Service Manual

SE-VC1180

- Notes:**
- This service manual is provided to indicate the main differences between the original model No. SE-CA1080 (E) and the subsequent model No. SE-VC1180 (E, EB, EG).
 - Refer to the Connections, Quick reference of remote control operation and Preparing of the remote control of Service manual for Model No. SL-VC1180 (E), Order No. AD9506160C2.

CHANGES

A OPERATION CIRCUIT

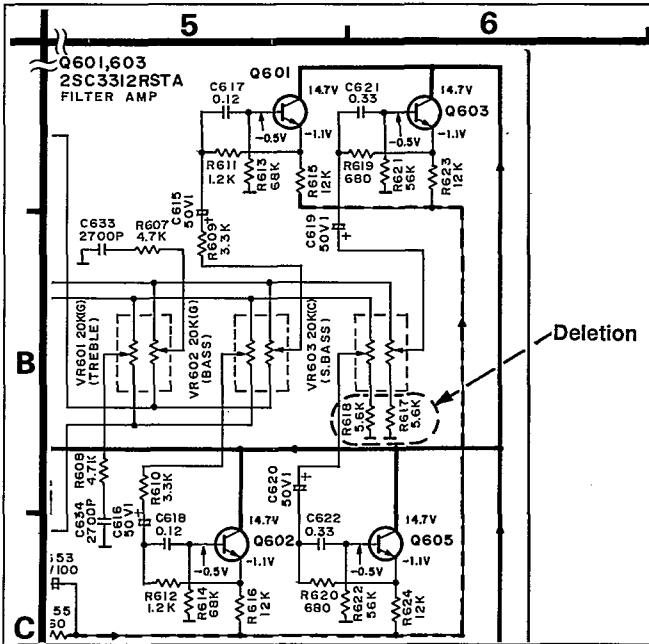
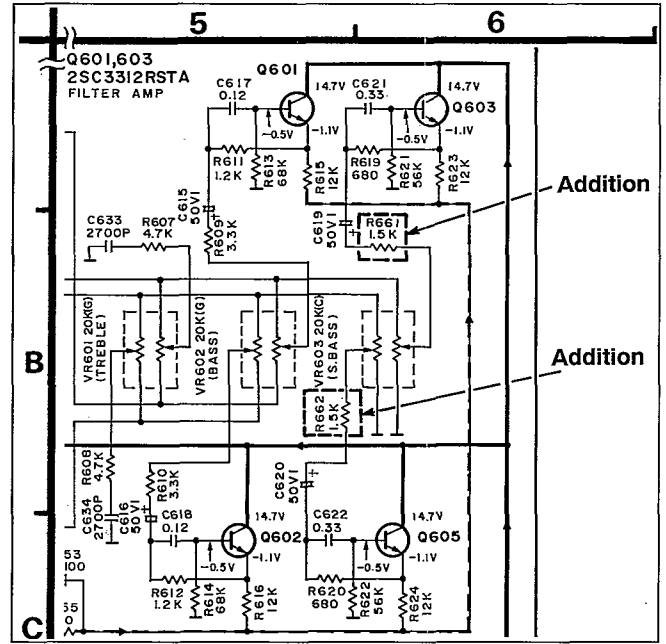
SCHEMATIC DIAGRAM (SE-CA1080 Service Manual of page 8.)

Note: Those parts have added.

A OPERATION P.C.B. (REP1924B-S)

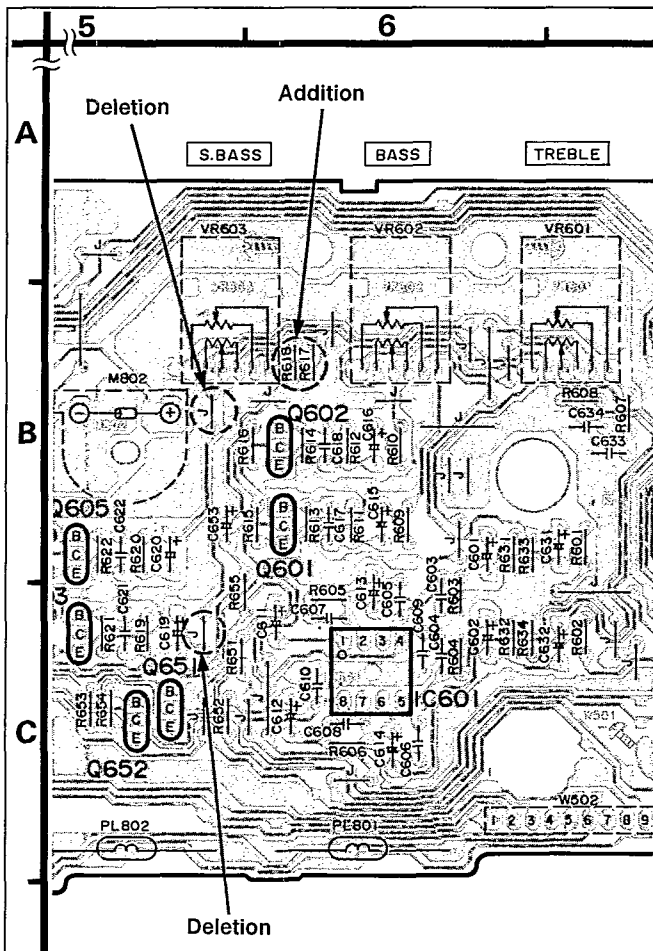
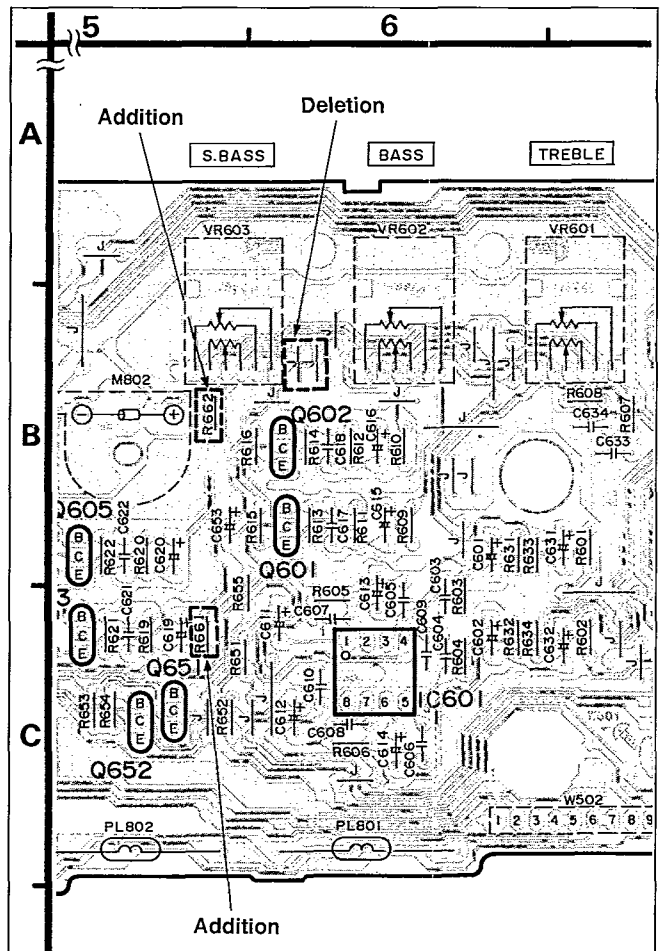
PRINTED CIRCUIT BOARDS (SE-CA1080 Service Manual of page 14.)

Note: Those parts have added.

CABINET PARTS LOCATION (SE-CA1080 Service Manual of page 16.)

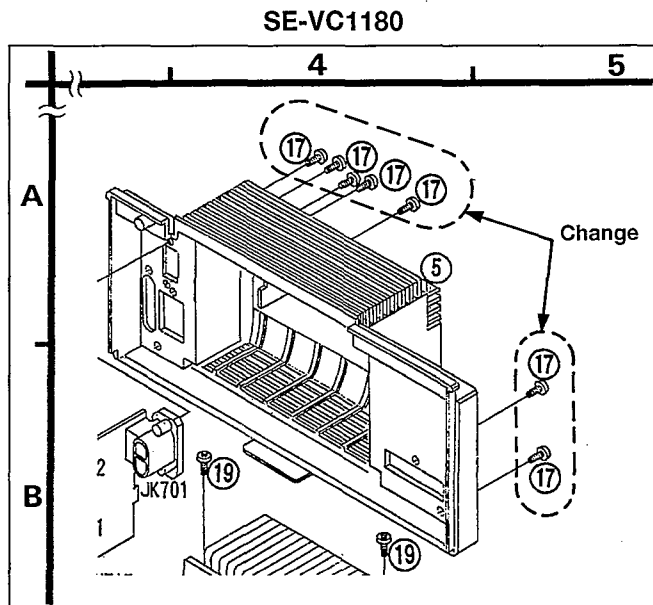
Note: Those parts have changed.
